**PLANNING COMMISSION REPORT**  
**Regular Agenda -Public Hearing Item**

**ITEM NO. 2: PRELIMINARY DEVELOPMENT PLAN FOR THE LINKS; 251 QUEENS RD (MKM)**

**PDP-14-00171:** Consider a Preliminary Development Plan for The Links at Lawrence, a 900 unit apartment complex, on approximately 78 acres located at 251 Queens Rd. Submitted by Blew & Associates PA, for Links at Lawrence, property owner of record.

**Figure 2a.** Sensitive Area Site Plan. Stands of Mature Trees shown in red, steep slopes above 15% in blue.

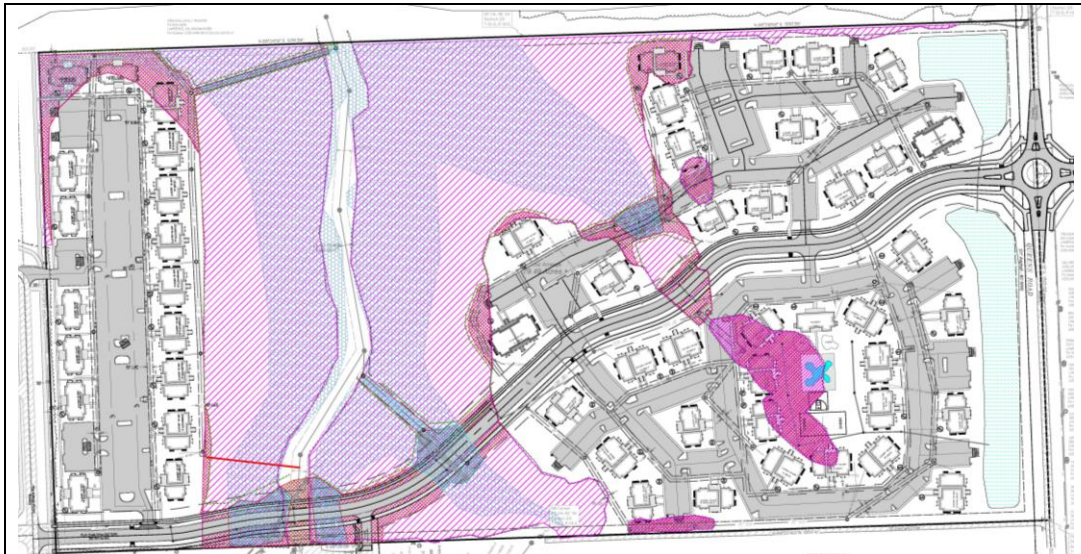
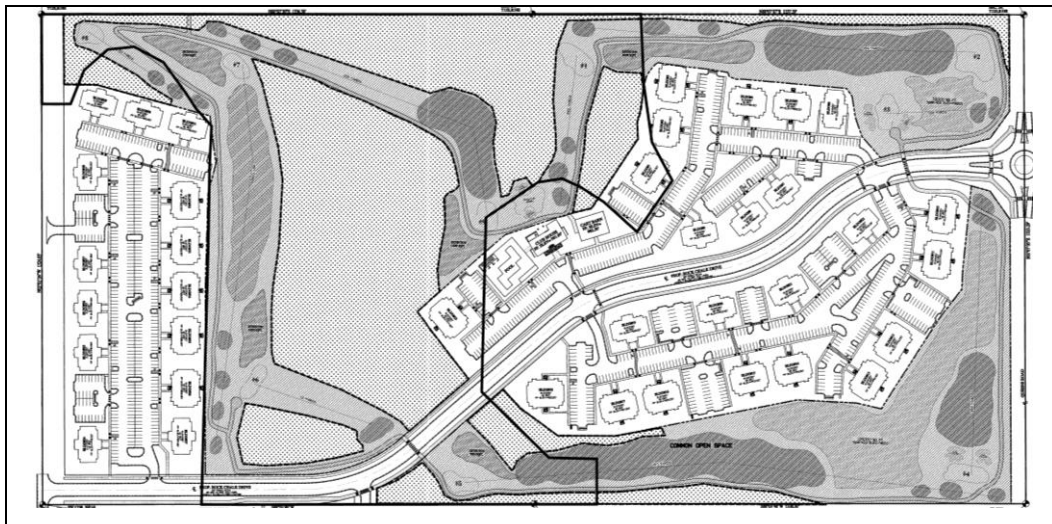
With the removal of the golf course from the wooded areas, the amount of contiguous wooded area that is preserved was increased. See Figure 2.

*Removing the proposed golf course from the wooded area allows a larger, more contiguous wooded area to be protected. A 50 ft to 100 ft clearing was created in a utility easement with the installation of the Baldwin Creek Interceptor Line. A 12' shared use path will be constructed by the property owner within the pedestrian easement to City standards, at the time of this development. The path will terminate 50' south of the north property line with a mini cul-de-sac. When a connecting trail has been constructed on the property to the north, the developer of this project will construct the remaining 12' wide connecting piece of the shared use path.*

- b. Provide a 12 ft Pedestrian Access Easement for the shared use path within the Utility Easement for the Sanitary Sewer Interceptor Line and add the following note: *"A 12' shared use path will be constructed by the property owner within the pedestrian easement to City standards, at the time of this development. The path will terminate 50' south of the north property line with a mini cul-de-sac. When a connecting trail has been constructed on the property to the north, the developer of this project will construct the remaining 12' wide connecting piece of the shared use path."*

**Figure 3b.** The changes with the current plan include the relocation of the recreational common open space and a reconfiguration of the building/parking area layout. (2012 approximate layout overlaid in red.)

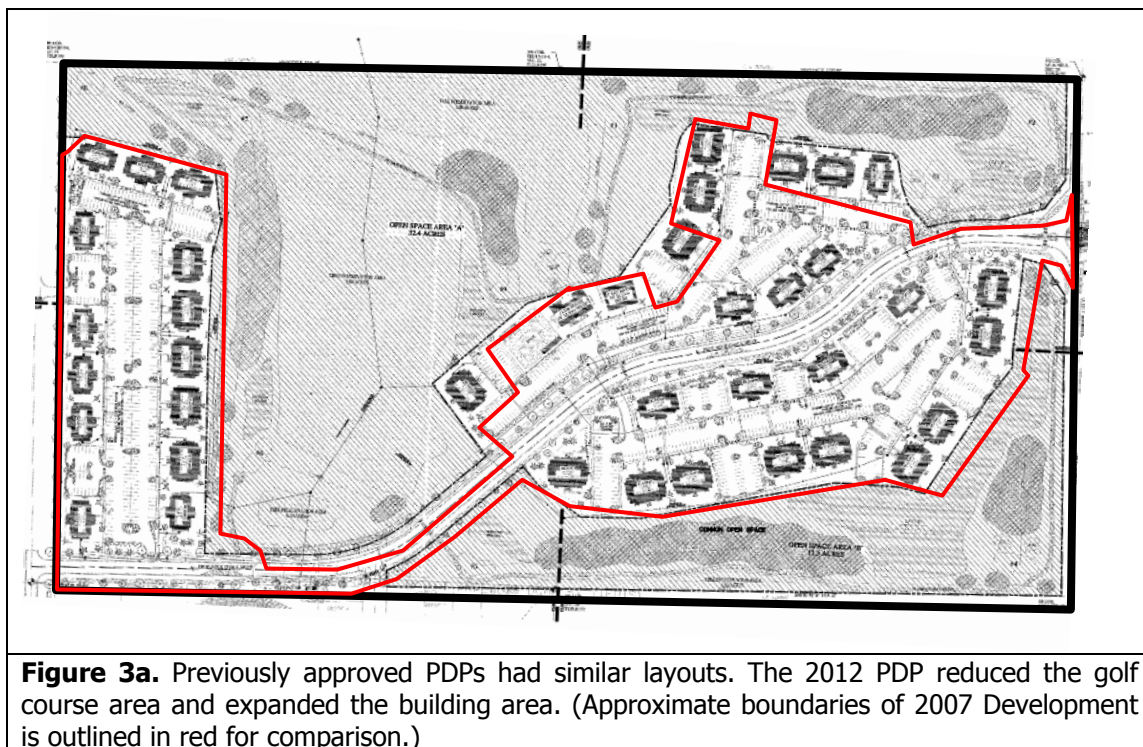
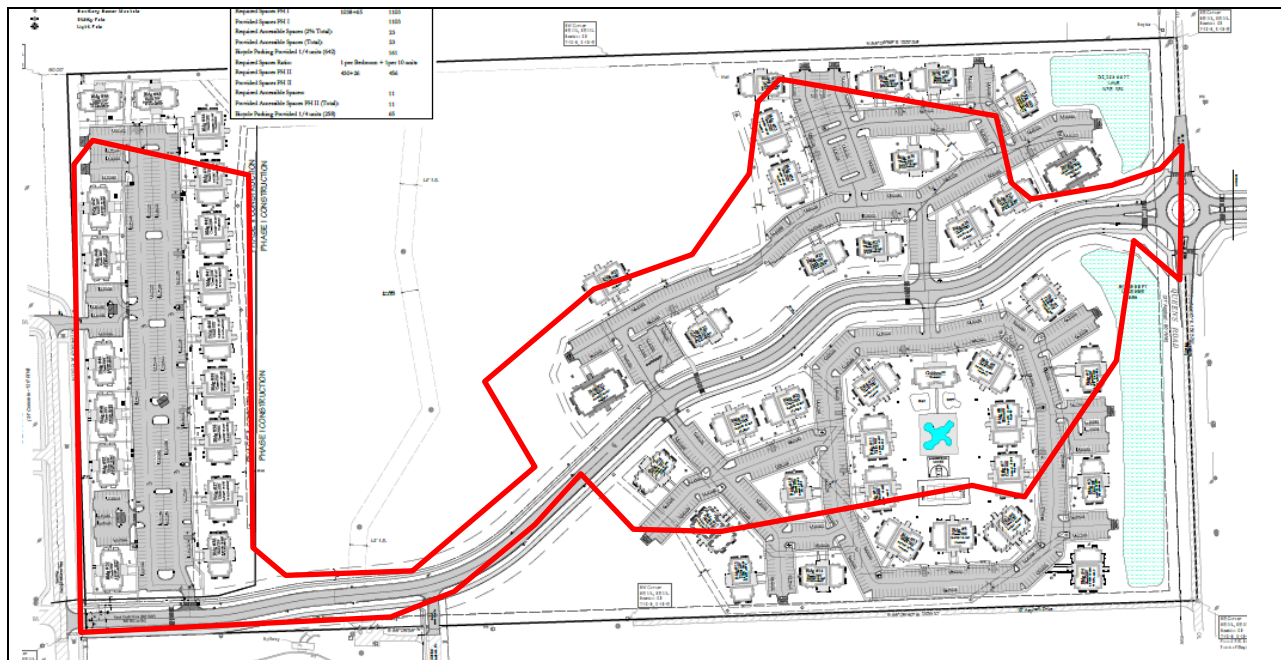
Figure 3 compares the development pattern in the previously approved PDP and that being proposed with the current PDP.

*Steep slopes were included in the sensitive area site plan, although the Development Code does not require their protection as environmentally sensitive lands. The improvements being proposed to the site are located outside of this area with the exception of a portion of Rock Chalk Drive and an access drive on the southern reach of the steep slopes. (Figure 3)*

**Figure 6.** Relationship with proposed development to the south.

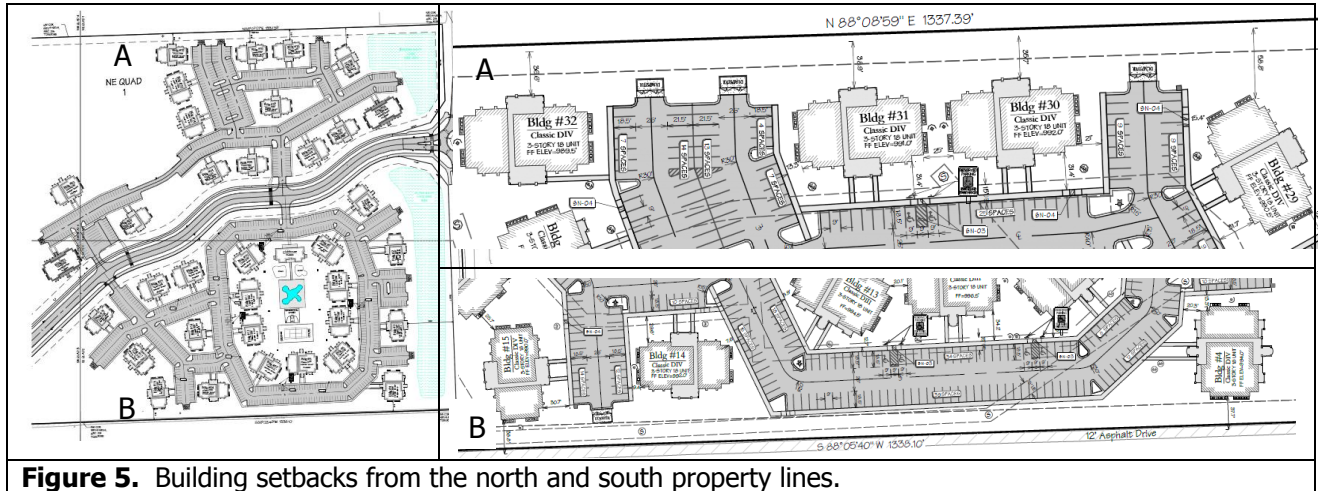
*The buildings are well setback from the adjacent streets, but are located near the north and south property lines as shown in Figures 5 and 6.*

*The buildings on the north and south perimeter of the project will be 3 story Classic IV models. This model does not have balconies. The buildings are setback from the adjacent properties a minimum of 35 ft from the north property line and 37 ft from the south property line. No development proposals have been submitted for the property to the north but it is expected to develop as single-dwelling residential, based on the recommendations of the Northwest Area Plan. The property to the south has single-dwelling zoning and a preliminary plat has been approved, Figure 6.*

*Three buildings and parking areas are located along the southeastern property line, adjacent to the proposed Kellyn Addition. The nearest buildings, approximately 37 ft from the south property line, are oriented so the sides face the south. These buildings do not contain balconies and a 25 ft Type 1 Bufferyard is proposed, as required by Code. In order to minimize impact to the adjacent single-dwelling residential development, a continuous hedge or solid fence or wall should be installed in this area to screen the parking areas from the nearby residences. The height of the buildings is mitigated by the bufferyard, the*

*37 ft setback and the fact that the buildings are oriented so the narrow portion fronts the adjacent property.*

2. Provision of a revised Preliminary Development Plan with the following changes:
  - a. Provide a continuous evergreen hedge, or 6 ft solid fence or wall along the south side of the parking/drive area in the Southeast Quadrant of the development adjacent to the proposed Kellyn Addition.
